Vermont Agency of Transportation
RECEIVED
CK'D BY JG, SC, TM   OK'D BY G. Laroche
February 15, 2016
RESUBMIT Yes   Rejected
BY K. Higgins   DATE 03/03/2016

APPROVAL STAMP:	J.P. CARRARA & SONS INC. Precast & Prestress Manufacturer 2464 CASE STR., MIDDLEBURY, VERMONT 05753 Phone:(802)388-6361 Fax:(802)388-9010	J.A. McDonald, Inc. CONTRACTOR LYNDON CENTER, VERMONT
	STATE OF VERMONT AGENCY OF TRANSPORTATION COUNTY OF RUTLAND	DATE: JAN. 8, 2016 SCALE: NOTED
	TOWN OF CLARENDON WALKER MOUNTAIN ROAD, TH #3, RURAL COLLECTOR BRIDGE NO.: 11 PROJECT NO.: BRO 1443(48)	CHKD: B.C. DFTM: T.D. JOB NO: 23476-015
	COVER SHEET	DWG. NO: C1

TOWN OF CLARENDON
WALKER MOUNTAIN ROAD, TH #3, RURAL COLLECTOR
BRIDGE NO.: 11 PROJECT NO.: BRO 1443(48)

S H I P P I N G   E L E V A T I O N

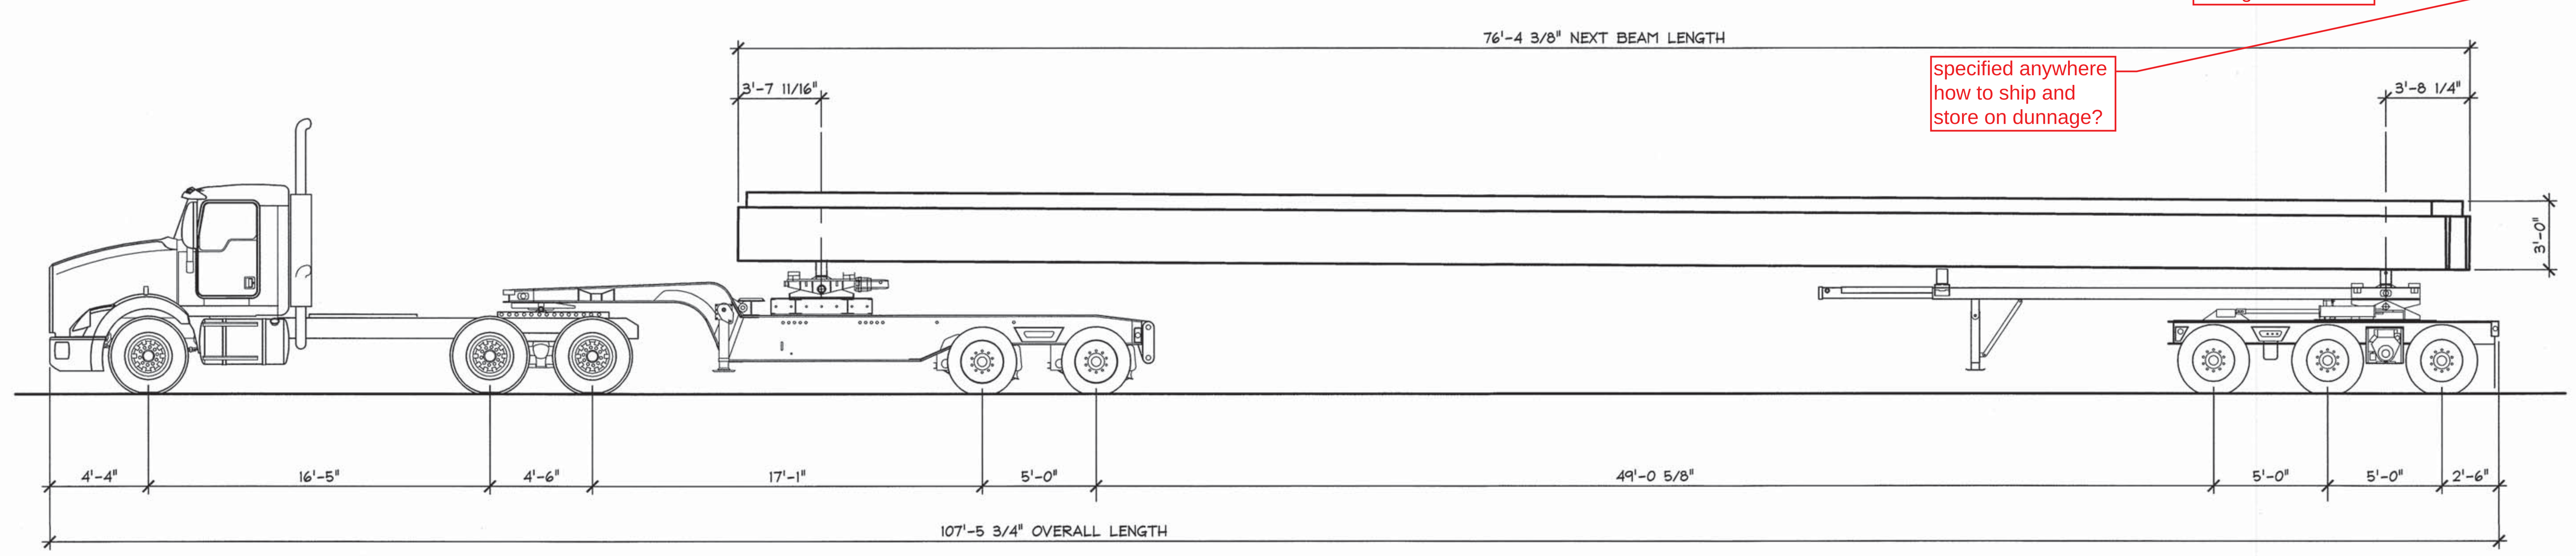
- specified anywhere how to ship and store on dunnage?
- Is this intended to be the form removal strength?
- ASTM A 1055
- 540.02 and 540.05
- before design strength

5 F3 APPROACH SLAB CLOSURE POUR

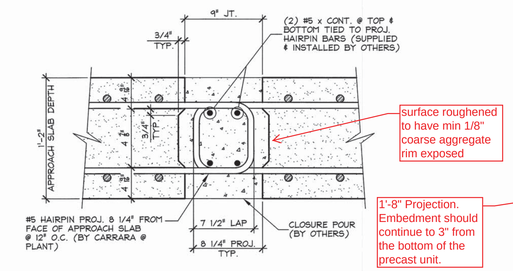
surface roughened to have min 1/8" coarse aggregate rim exposed

6 F3 ABUTMENT SECTION

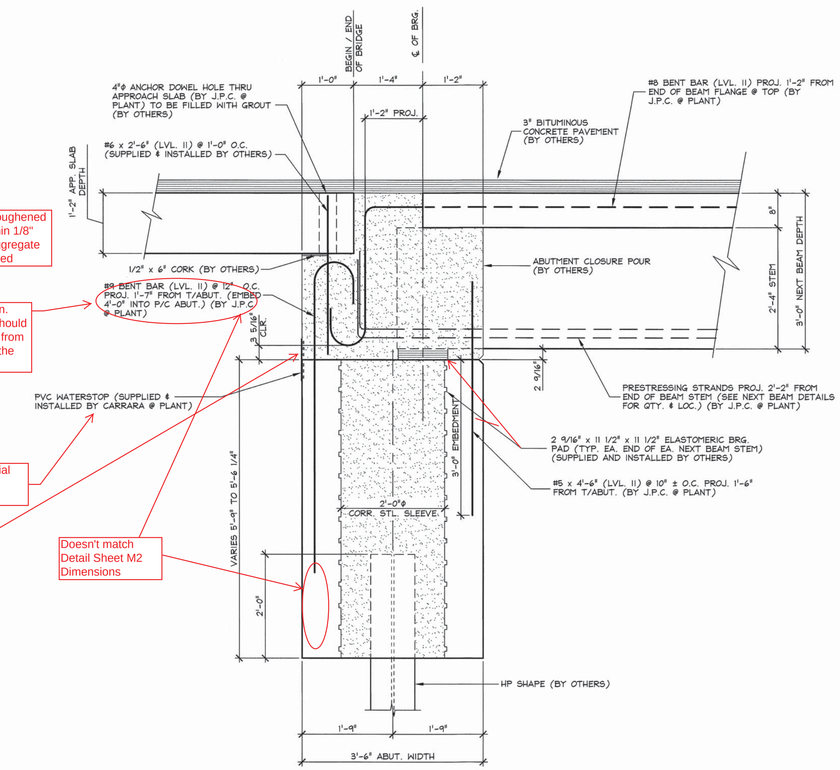
1'-8" Projection. Embedment should continue to 3" from the bottom of the precast unit.

Provide Material Spec. for PVC Waterstop

where does this terminate horizontally?

Doesn't match Detail Sheet M2 Dimensions

1 ABI — ABUTMENT DIMENSIONAL DETAILS

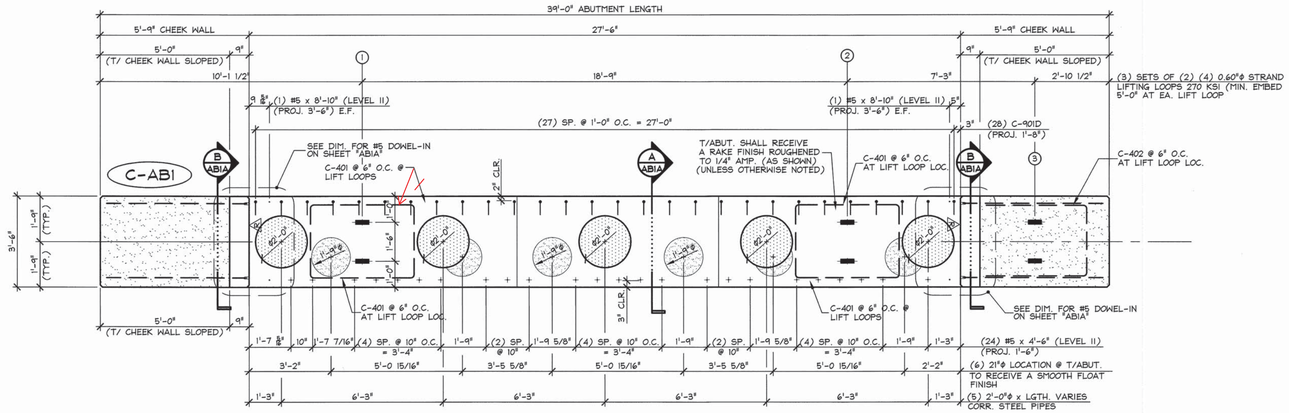
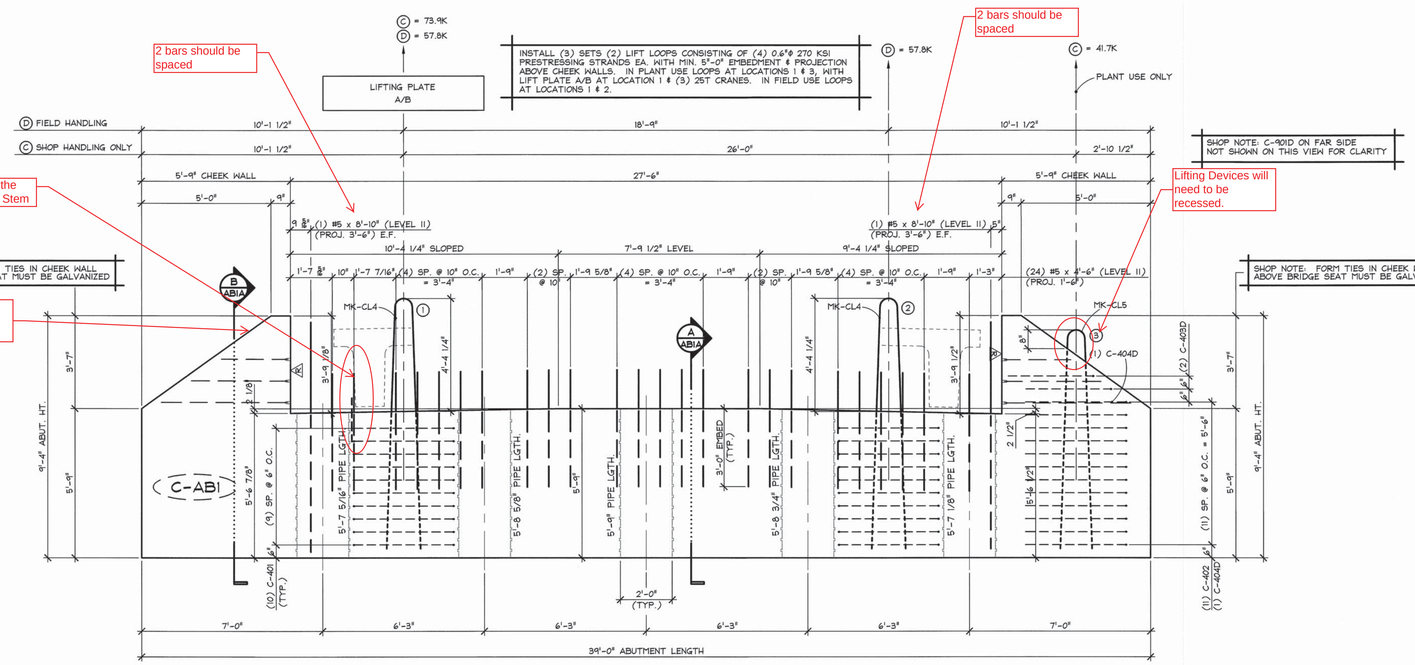
Stripping? and is that strength corrrect?

newer approved mix now

B ABIA ABUTMENT SECTION (C-ABI) 3/4" = 1'-0"

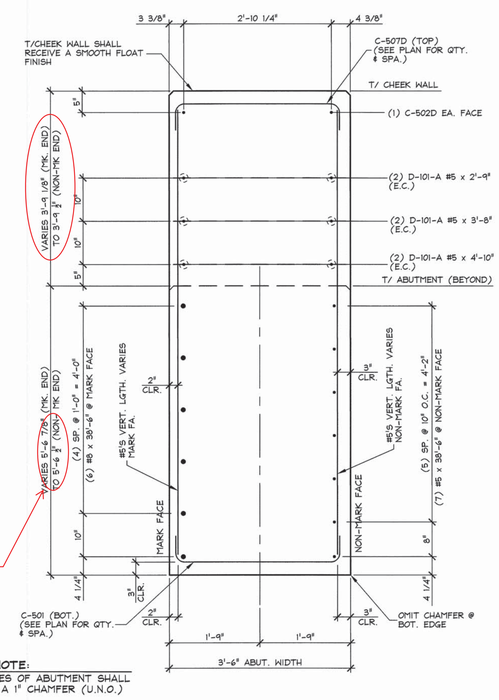
Why do the vertical dimensions vary from NF to FF or MARK FACE TO NON MARK FACE?

1 AB2 ABUTMENT DIMENSIONAL DETAILS

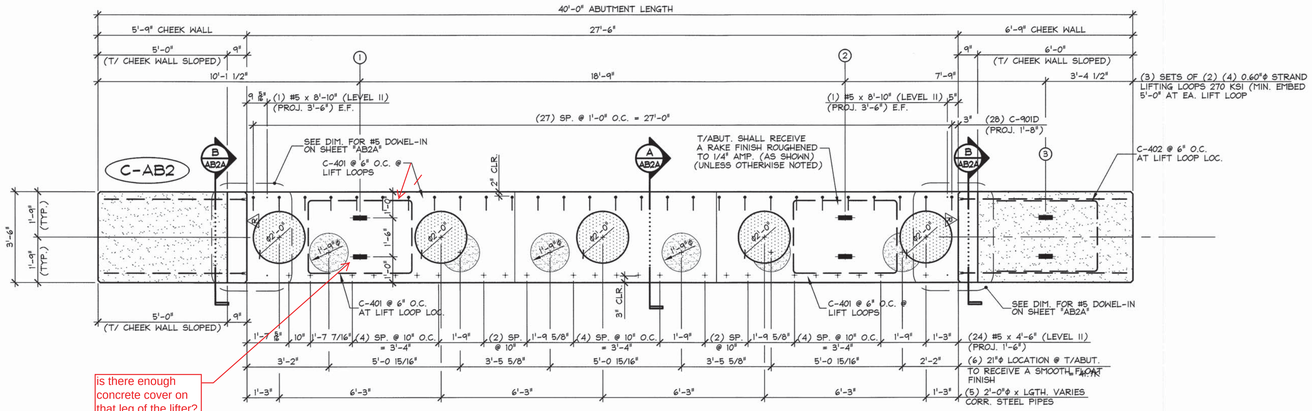
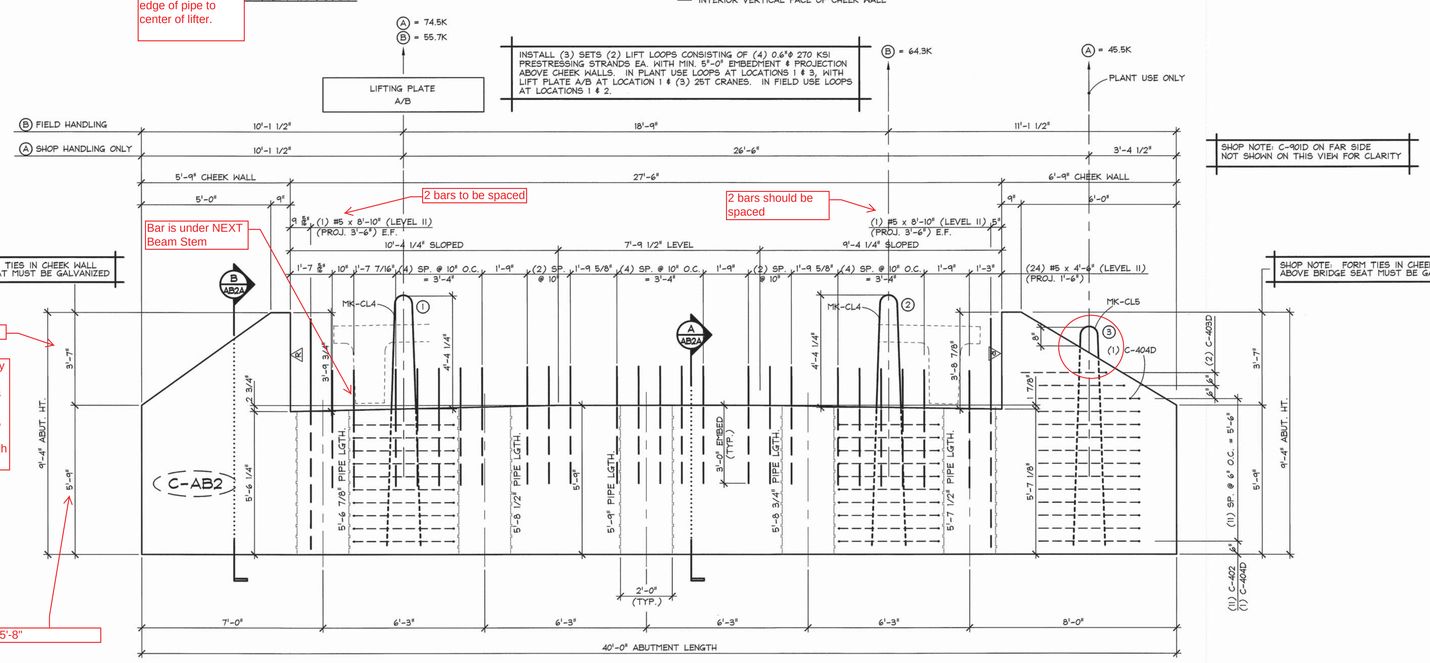
is there enough concrete cover on that leg of the lifter? I calculate 4" from edge of pipe to center of lifter.

same question as above

1 AB2A ABUTMENT REINFORCING DETAILS 3/8" = 1'-0"

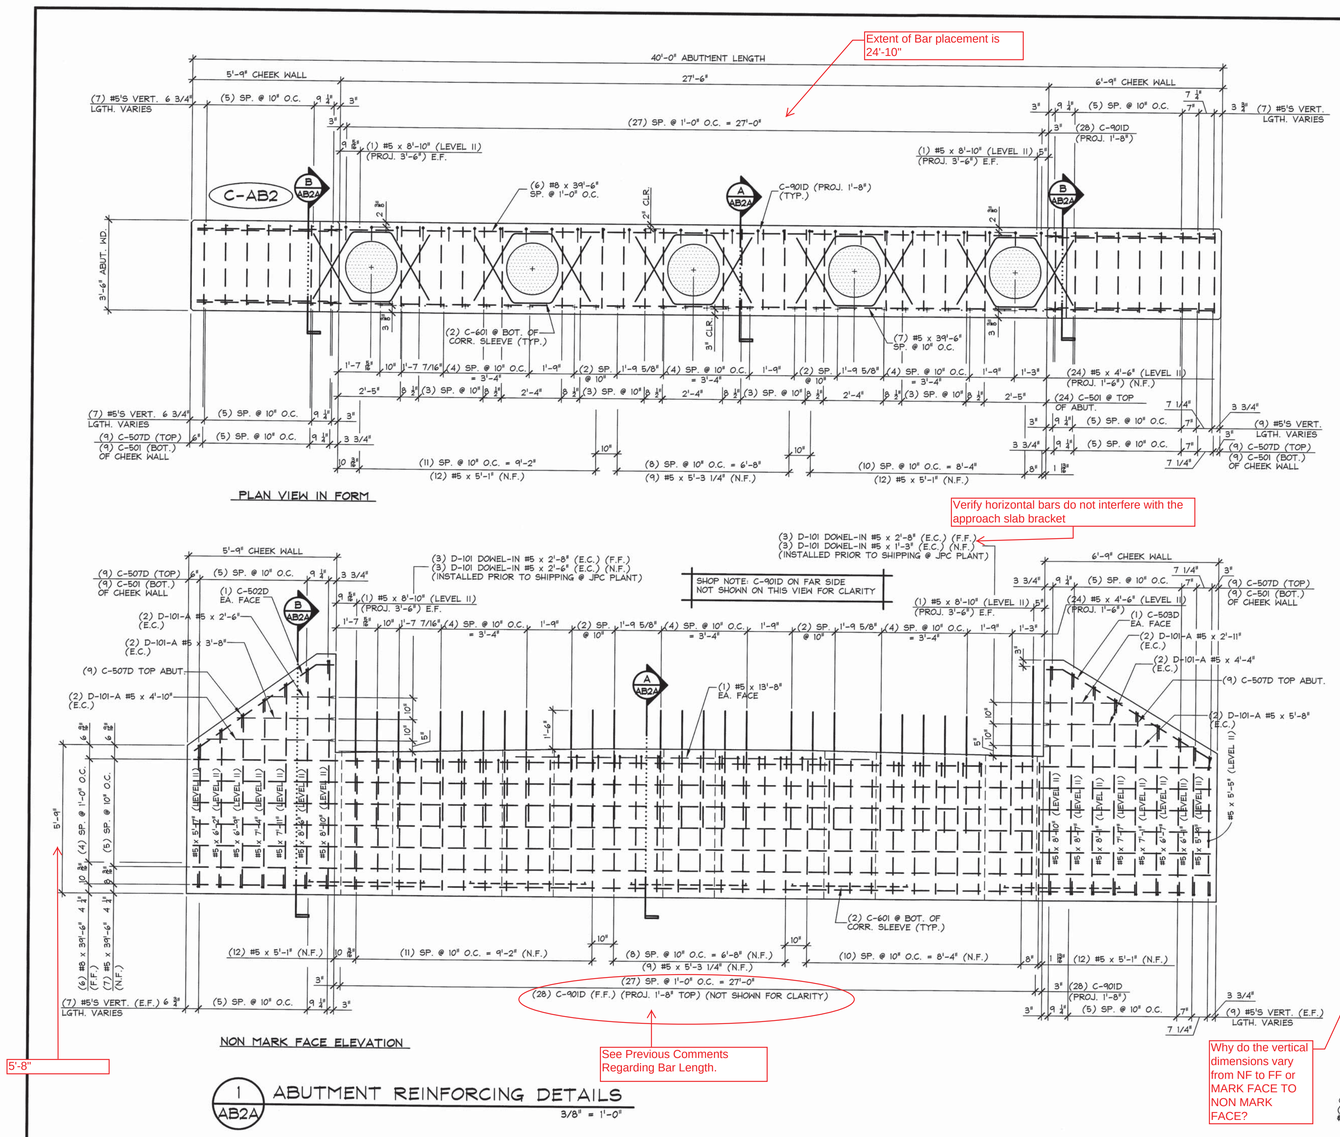
See Previous Comments Regarding Bar Length.

B AB2A ABUTMENT SECTION (C-AB2) 3/4" = 1'-0"

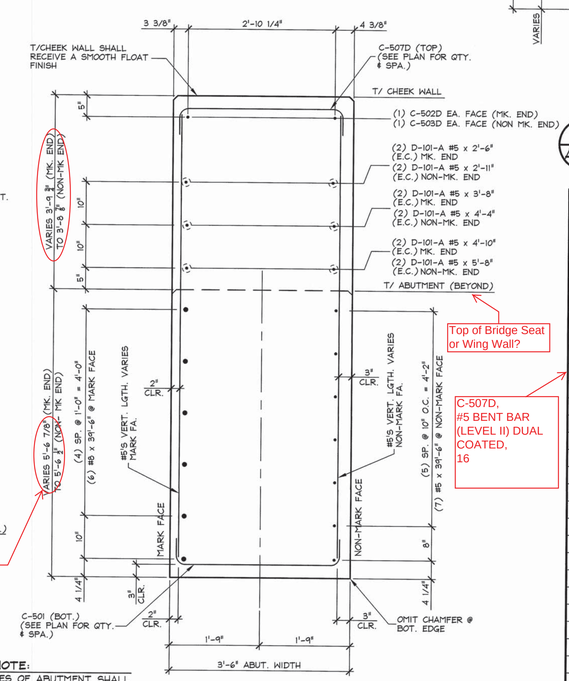
Why do the vertical dimensions vary from NF to FF or MARK FACE TO NON MARK FACE?

1 NB1 DIMENSIONAL PLAN VIEW IN FORM "C-NB2"

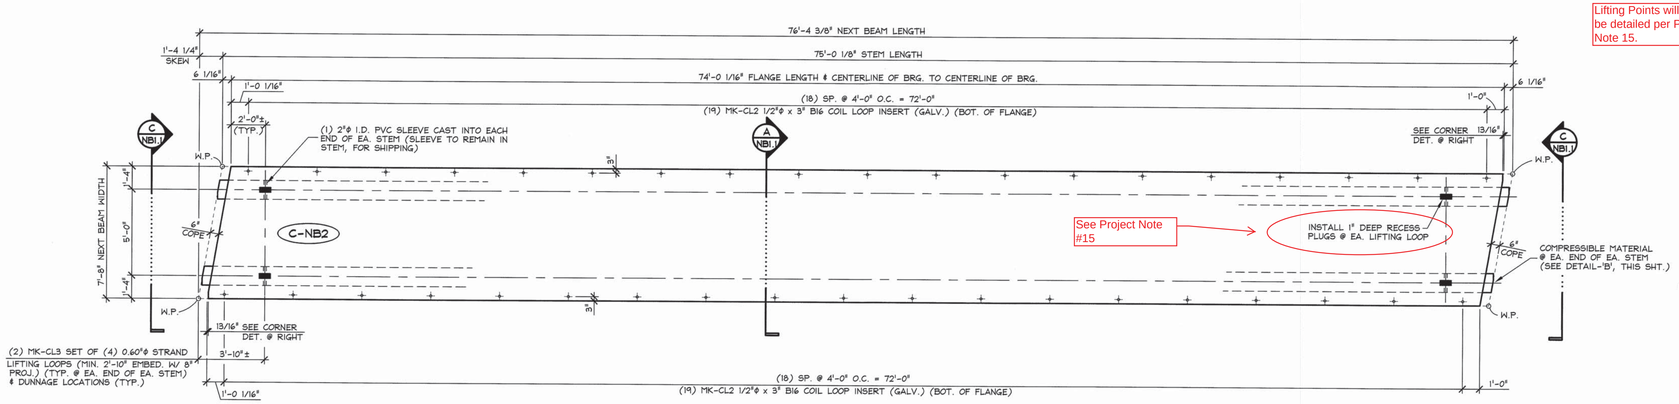
Lifting Points will need to be detailed per Project Note 15.

Use a 3" x 3" chamfer on Acute Corners of the Flange

2 NB1 REINFORCING PLAN VIEW IN FORM "C-NB2"

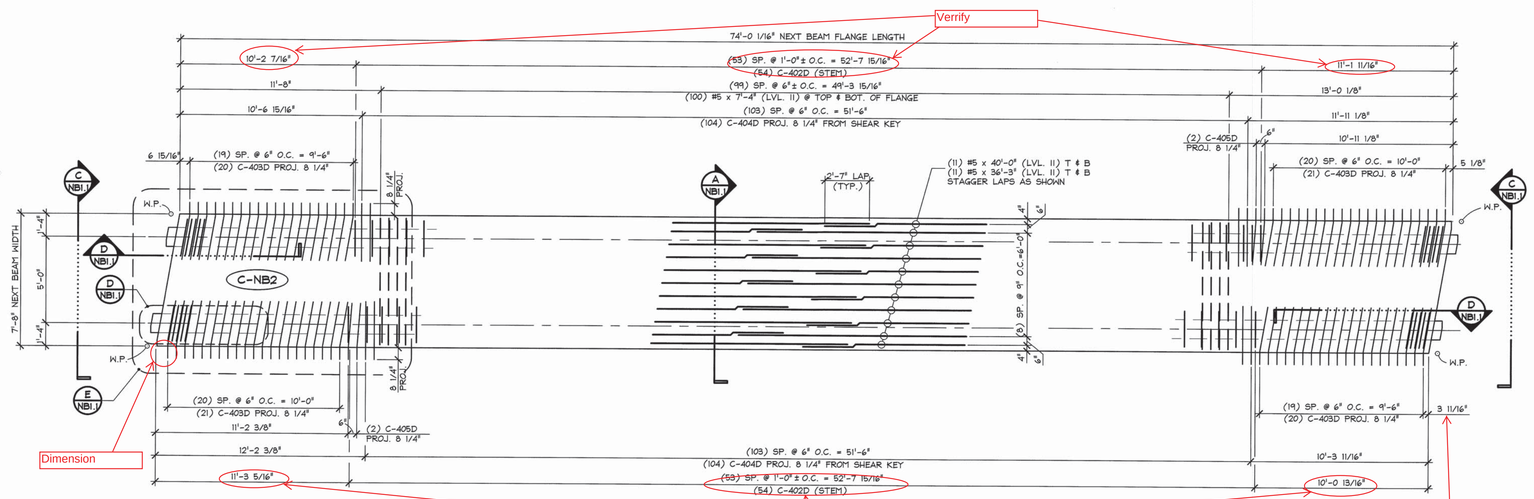
C-403D bars conflict from NB2 to (NB3, OR NB1 REVERSED)) Either Provide additional details, or revise dimensions so bars no longer conflict each other.

A NB1.1 DIMENSIONAL & REINFORCING SECTION @ MID-SPAN
3/4" = 1'-0"

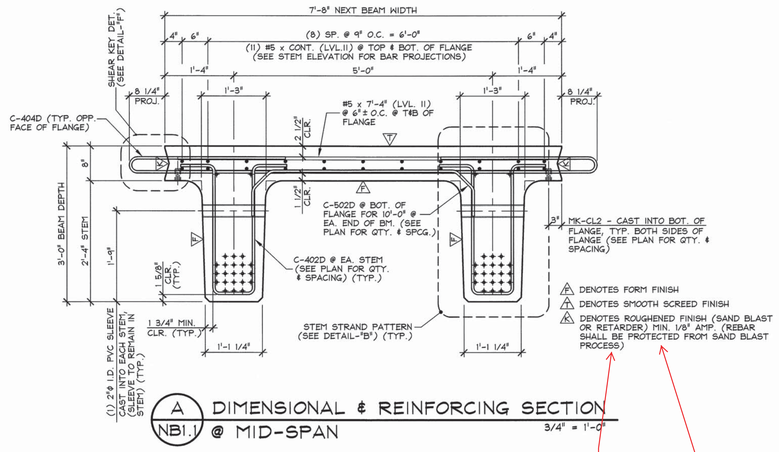
I believe from last year these shear keys are to have a min of 1/8" coarse aggregate rim exposed

Will the roughened finish be achieved through sand blasting and retarder?

STEM PLAN

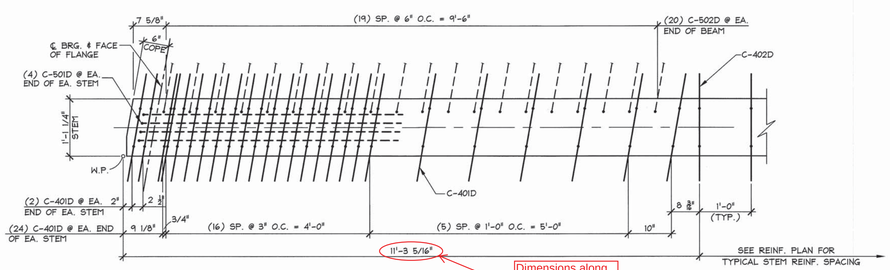
Dimensions along C-401D do not add up.

E NB1.1 ENLARGED TRANSVERSE REINFORCING PLAN
LONGITUDINAL REINFORCING & STEM STIRRUPS NOT SHOWN FOR CLARITY
1/2" = 1'-0"

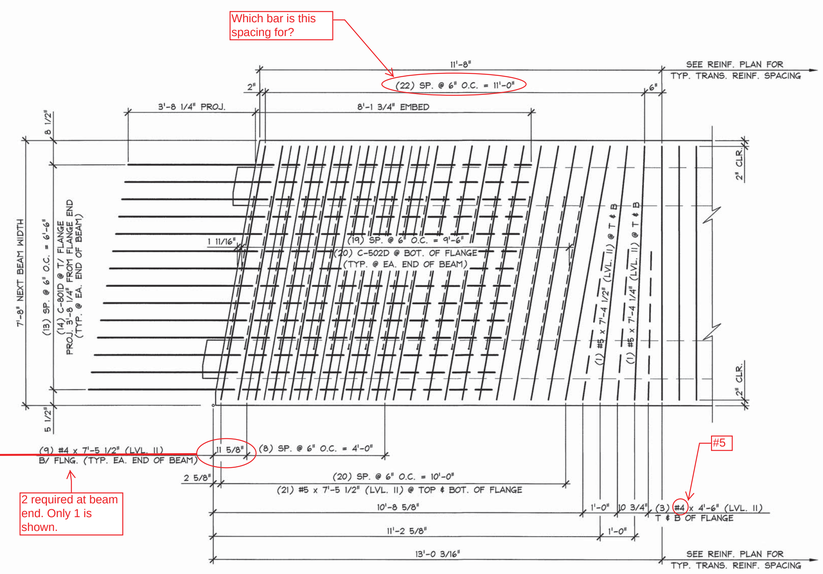
2 required at beam end. Only 1 is shown.

D NB1.1 END BLOCK STEM REINFORCING DETAILS
3/4" = 1'-0"

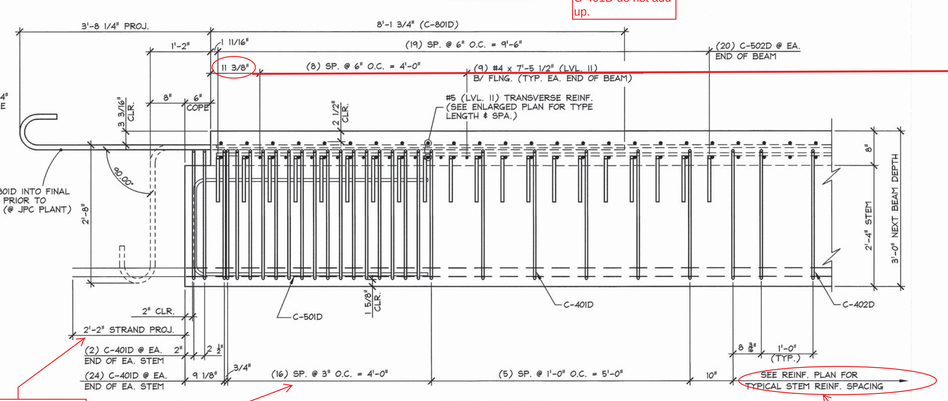
Strands require 90 deg bend. Label work to be done by others.

Doesn't match Stem Plan

C-403D, C-404D, C405D should either be detailed here or there should be a note that they are ommited for clarity
